GRAVELY *Technical* BULLETIN

BULLETIN NO. 1030
DATE: September 6, 1963
TO: ALL OUTLETS
SUBJECT: 1. Leaf-Away Modification
2. Pump Cup Wear on 20-Gallon Sprayer

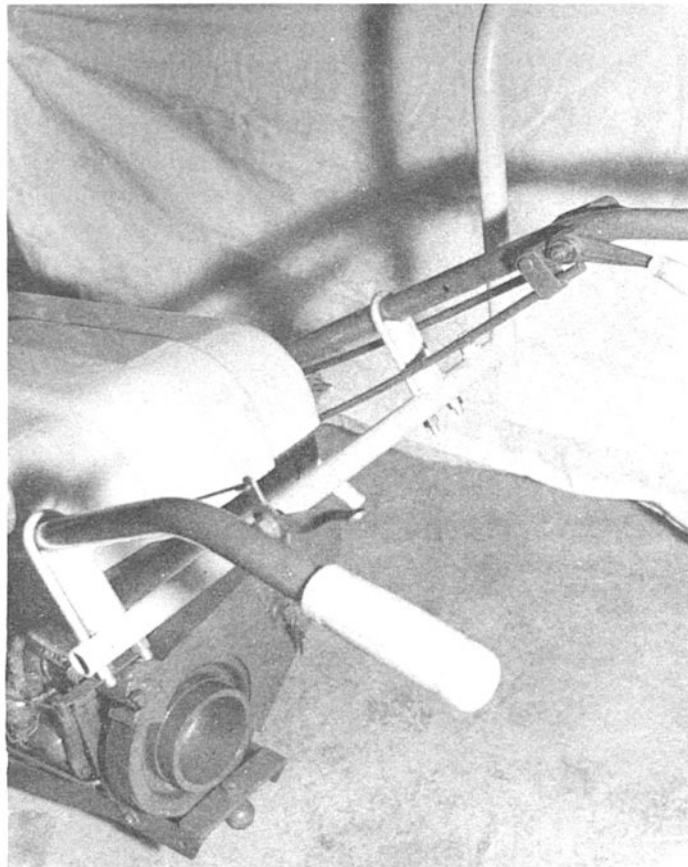
The Leaf-Away has been modified slightly to permit its use on Tractors with the Super or Custom Hoods.

As shown in the photo, a new Handle Bar Support (Part Number 6245) is used. Also, two new U-Bolts (Part Number 6246) are employed.

The modified Leaf-Away, now standard production, can also be used on Tractors with old Hoods.
